HISTORIC AND DESIGN REVIEW COMMISSION

November 16, 2022

HDRC CASE NO: 2022-399
ADDRESS: 363 NORTH DR
LEGAL DESCRIPTION: NCB 7026 BLK 5 LOT 16, E11 FT OF 18
ZONING: R-6, H
CITY COUNCIL DIST.: 7
DISTRICT: Monticello Park Historic District
APPLICANT: Thomas Gandy/GANDY THOMAS R
OWNER: Thomas Gandy/GANDY THOMAS R
TYPE OF WORK: Exterior modifications, fenestration modifications
APPLICATION RECEIVED: July 24, 2022
60-DAY REVIEW: Not applicable due to City Council Emergency Orders
CASE MANAGER: Edward Hall

AD-10

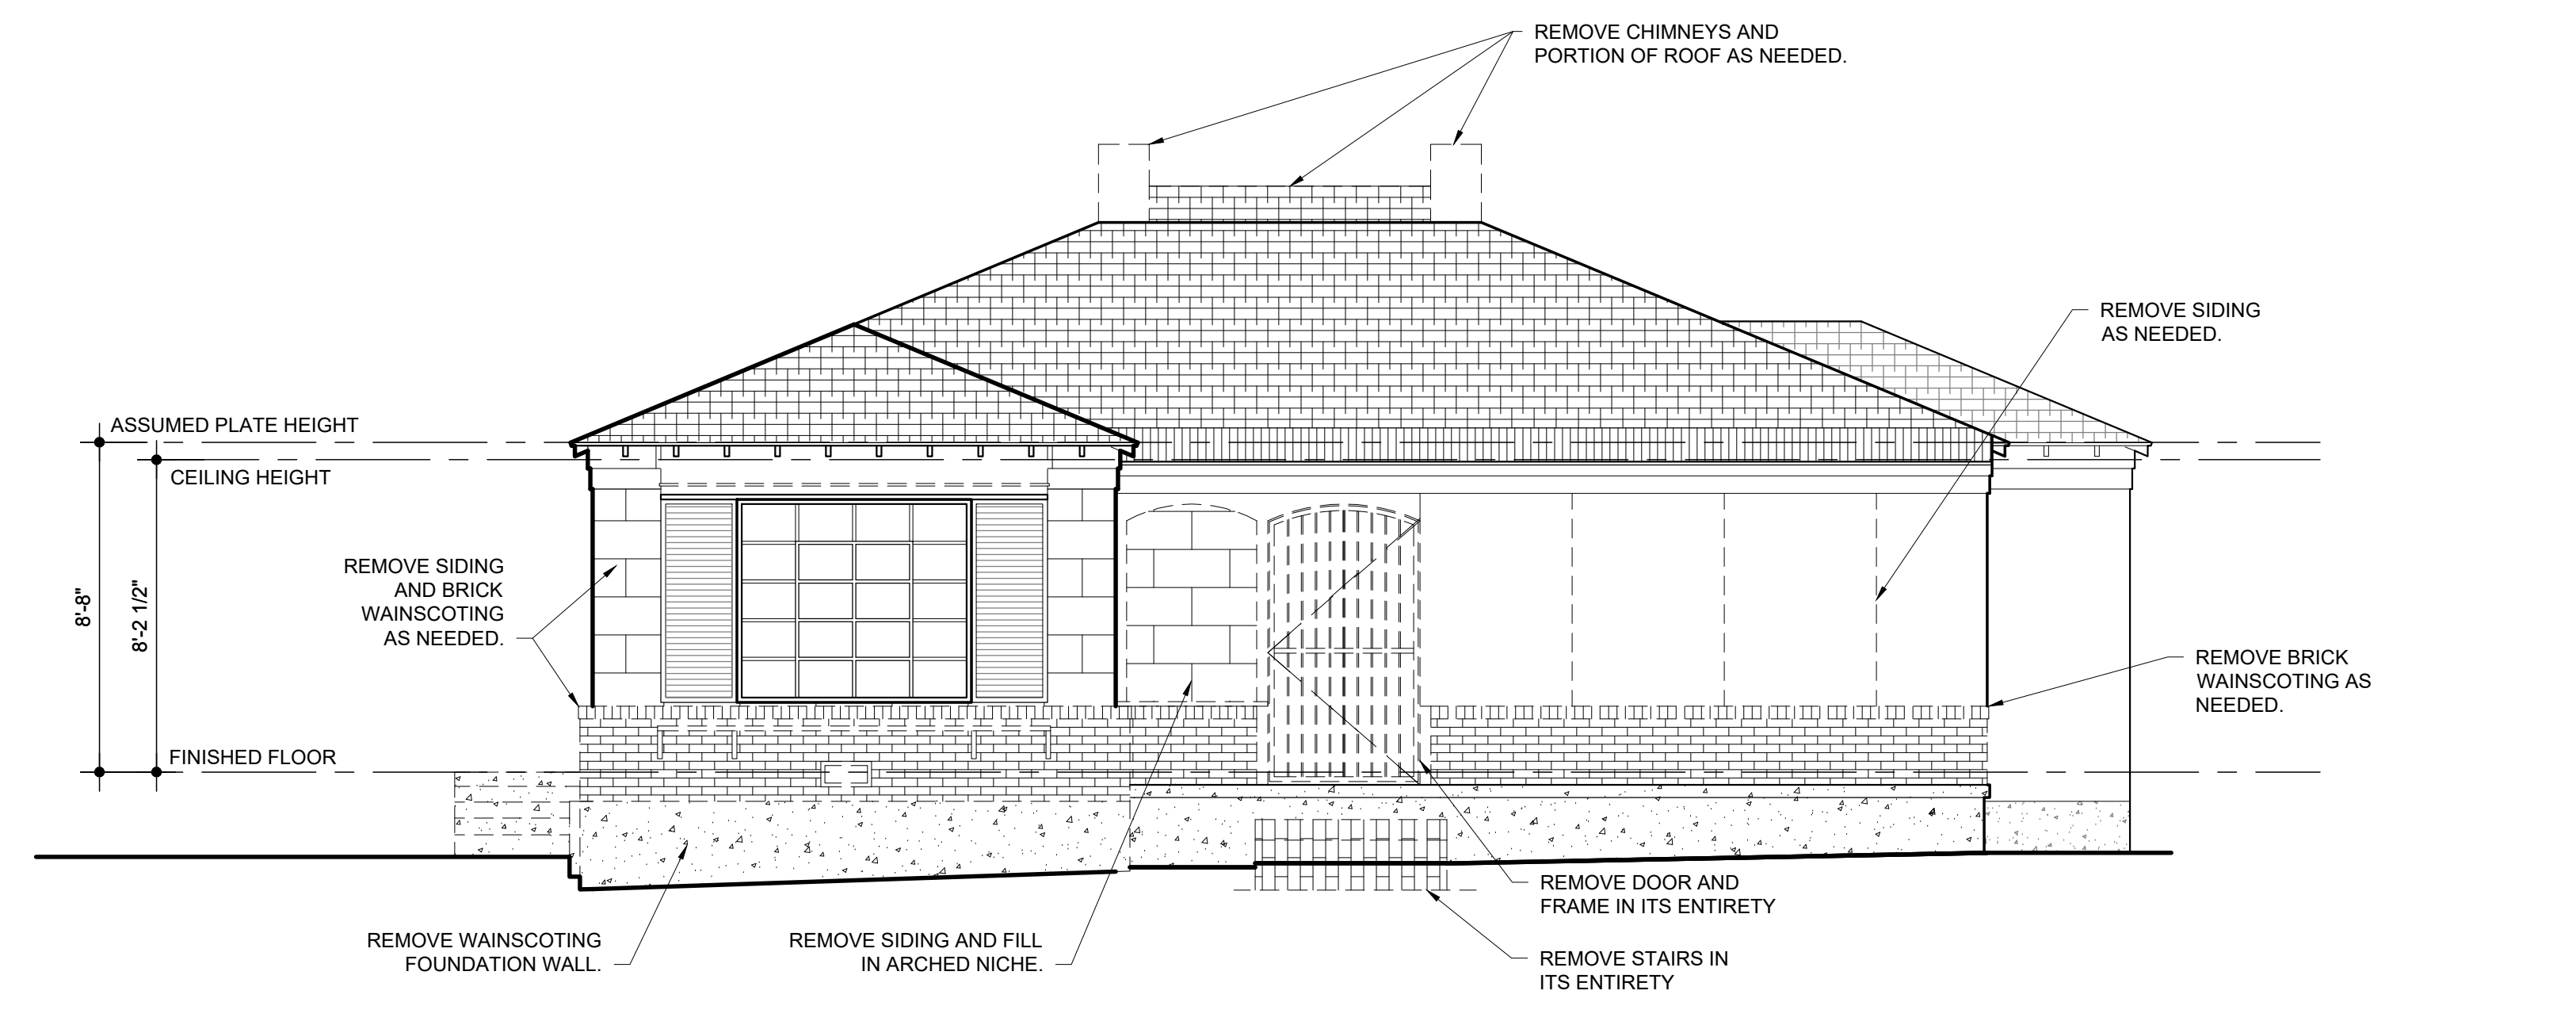
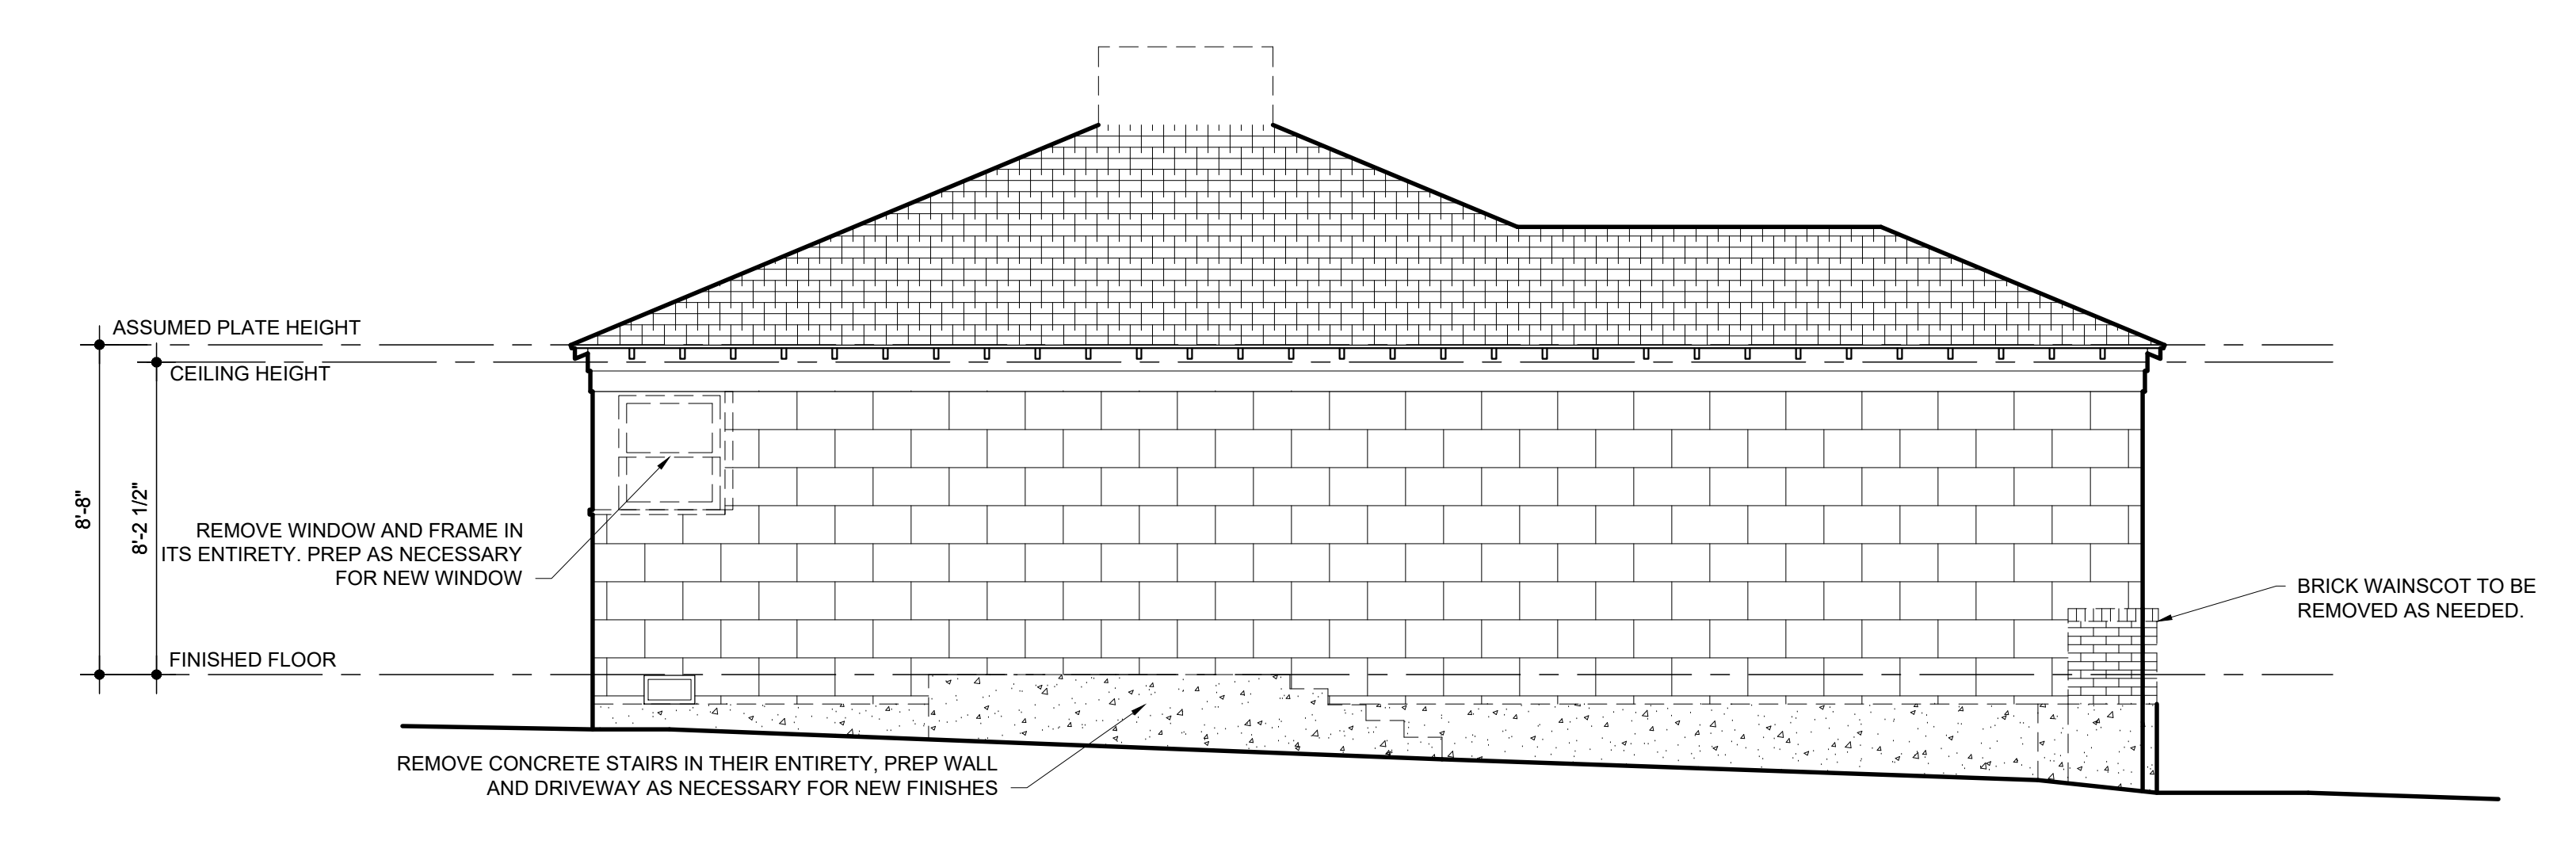
- f. EXTERIOR MODIFICATIONS (Front Façade) – The applicant has proposed to perform modifications to the front façade to include the installation of two, one over one windows on the front façade. This wall plane is not original and is the front of a previously enclosed front porch. The Guidelines for Exterior Maintenance and Alterations 7.A and B. note that front porches should not be enclosed. When porches are enclosed, the Guidelines note that they should function and visible read as a porch. Per photos, the front porch has been enclosed with screening elements since 2007, at least. Staff finds that either windows should be added across the entirety of the enclosed porch to read as an open element with visible porch columns, or that the structure should be returned to its previous condition.

- g. EXTERIOR MODIFICATIONS (Side Façade) – The applicant has proposed to perform modifications to the side (west) façade to include the removal of an existing door opening, and the removal of an existing concrete stoop and steps. Per the Guidelines for Exterior Maintenance and Alterations 6.A.i., exiting window and door openings are to be preserved. The proposal to remove the existing, side door is inconsistent with the Guidelines.

- h. FRONT PORCH STEPS – The applicant has proposed to install new, rounded concrete porch steps as well as a concrete apron to the proposed porch steps. The existing steps are clad in brick, but feature a minimal design and a width that is slightly wider than that of a pedestrian door opening. There is no historic precedent of an alternative porch design on site or within the district. Staff finds that the existing porch steps form should be maintained. In-kind replacement, with concrete would be appropriate, with no change to profile.

2. Staff does not recommend approval of item #2, modifications to the front façade, as noted in finding f. Staff recommends that either windows be added across the entirety of the enclosed porch to read as an open element with visible porch columns or that the structure be returned to its previous condition.

3. Staff does not recommend approval of item #3, modifications to the side (west) façade to include the removal of an existing door opening, and the removal of an existing concrete stoop and steps, as noted in finding g. Staff recommends that the door opening, concrete stoop and stairs be preserved.

4. Staff does not recommend approval of item #4, the installation of new, rounded concrete porch steps and a concrete apron as noted in finding h. In-kind replacement, with concrete would be appropriate, with no change to profile.
